## TECHNICAL BULLETIN

[Issue No.] GOT-A-0166

[Title] Description Change on the Rating Plate and Removal of the Battery Caution Plate for GT25 Wide Models (10.1 and 7 Inches)

[Relevant Models] GOT2000 Series

#### 2.1 Rating plate

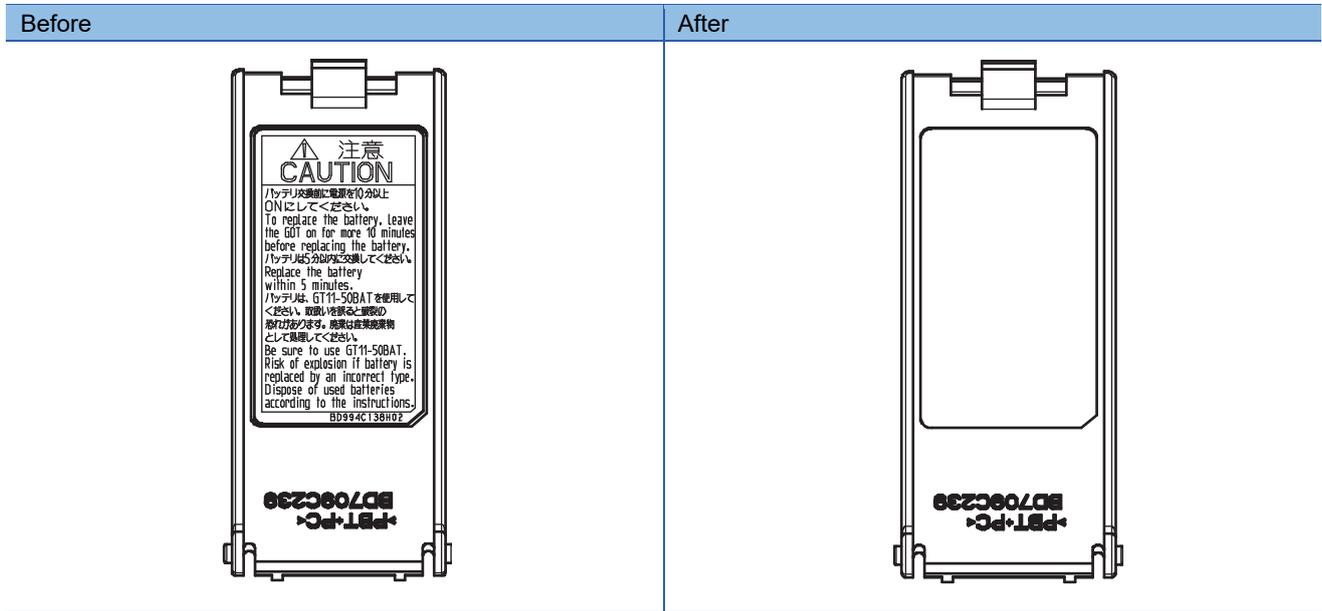
The caution mark will be added on the bottom right of the rating plate.
